EG&G ROCKY FLATS, INC.

93-RF-14028

SW-59 DIVERSION AND MODIFICATION TO THE SAMPLING PLAN FOR THE OPERABLE
UNIT 2 SURFACE WATER INTERIM MEASURES/INTERIM REMEDIAL ACTION (11735) - NMH-
587-93

OPERABLE UNIT 2
 SURFACE WATER COLLECTION

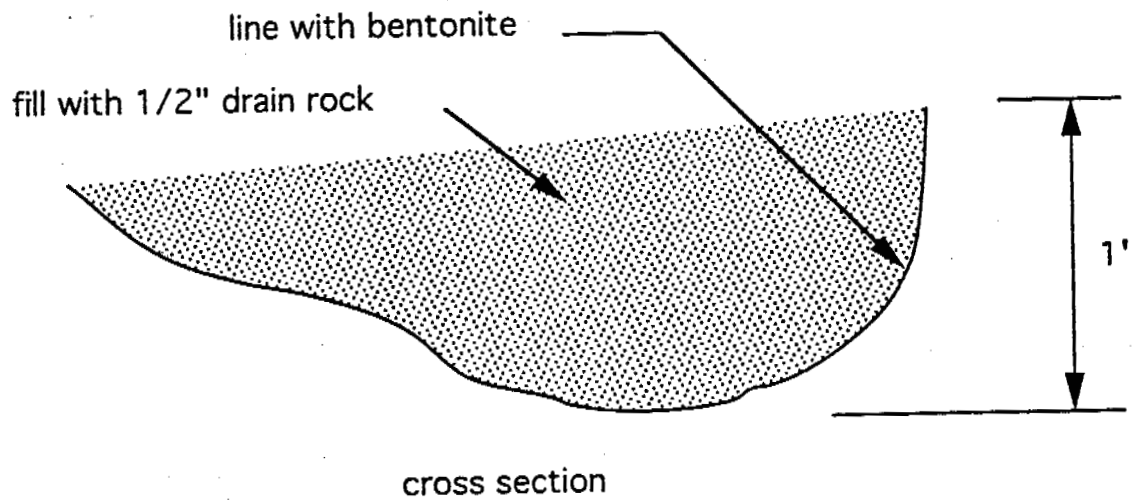
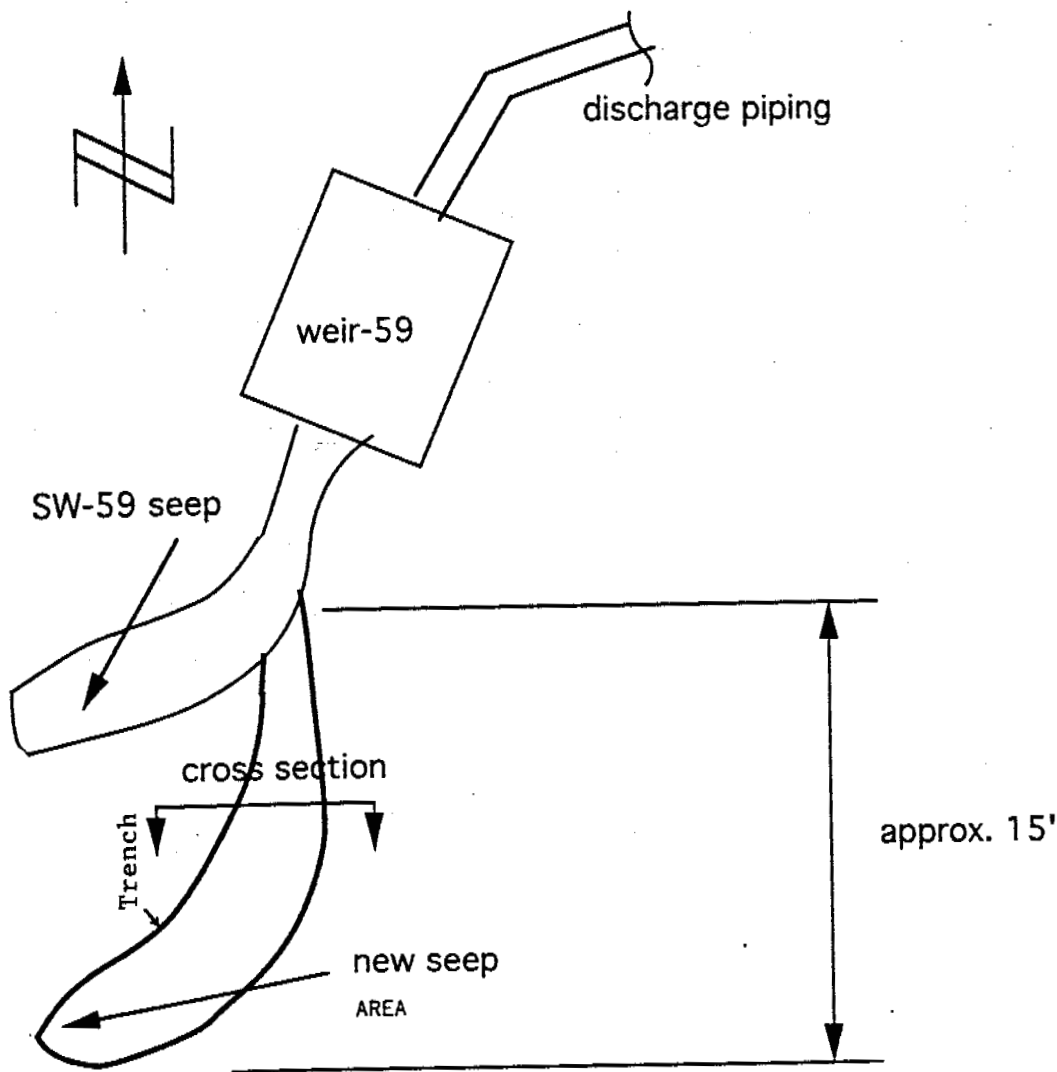
In response to the above referenced request, the source of SW-59 is in the process of being characterized. To ensure that all water is collected, EG&G Rocky Flats, Inc. proposes to modify the seep areas as per the attached drawing. A trench will be excavated to a maximum depth of one foot across the downhill area of the new seep. The trench will be lined with bentonite and back filled with 1/2 inch diameter drain rock. This trench will be connected to the existing SW-59 collection sump and enable all contaminated water from this source to be collected and treated. No modifications to the Operable Unit 2 Interim Measures/Interim Remedial Action Sampling and Analysis Plan (SAP) will be required for this seep. However, the SAP is currently being modified to reflect current changes in sampling requirements.
